## **DRAWINGS**

## **REMARKS**

Fig.2.

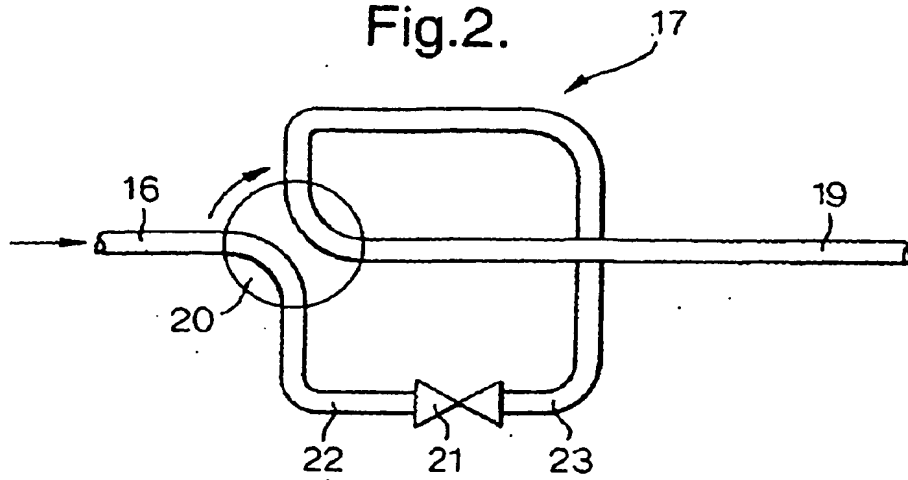
The Office Action also objects to the drawings as failing to comply with 37 CFR 1.84(p)(5), because they are found not to include reference sign "30" mentioned in [0032] of the specification.

This objection has been overcome by amendment of Fig. 3 to include reference sign "30" in the same way as reference sign "17" in Fig. 2. No matter has been added.
